ADDENDUM 01

Project: Upstate – Palmetto Villas Crawl Space Repairs

JCS Project #: 18108

Date: 4/18/2019

VILLA #6 CRAWLSPACE
SCALE 1/8" = 1'-0"

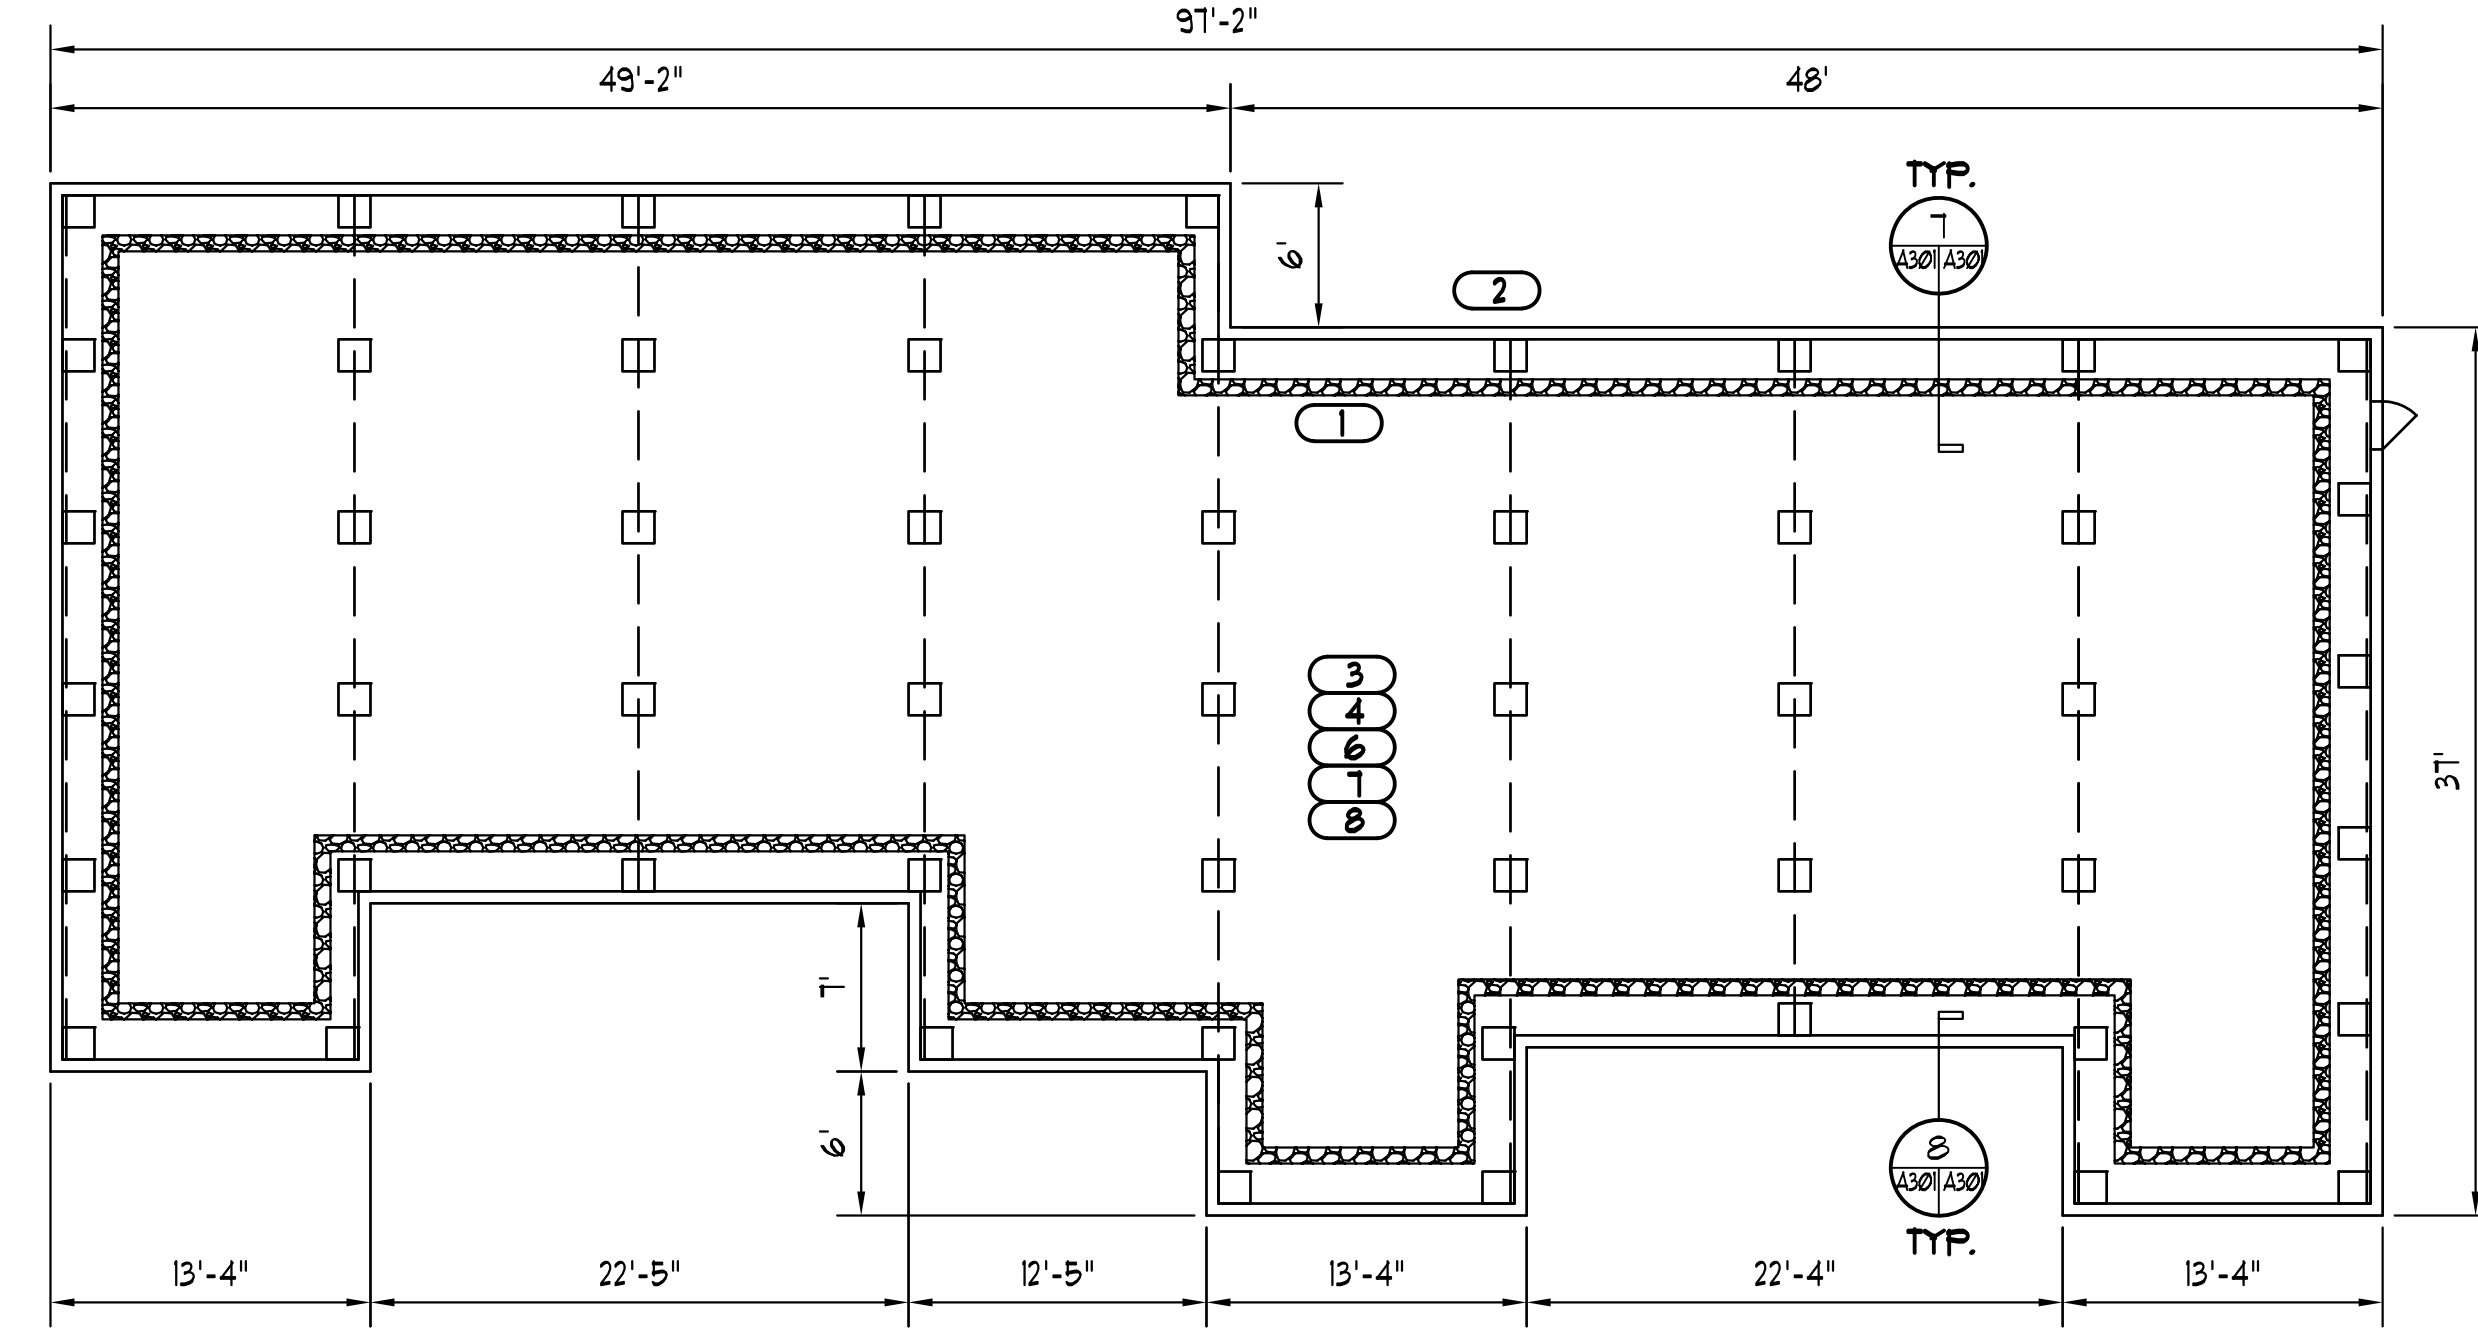
1. **Sheet A301, Crawl Space Plans and Details.** See attached revised sheet A301.
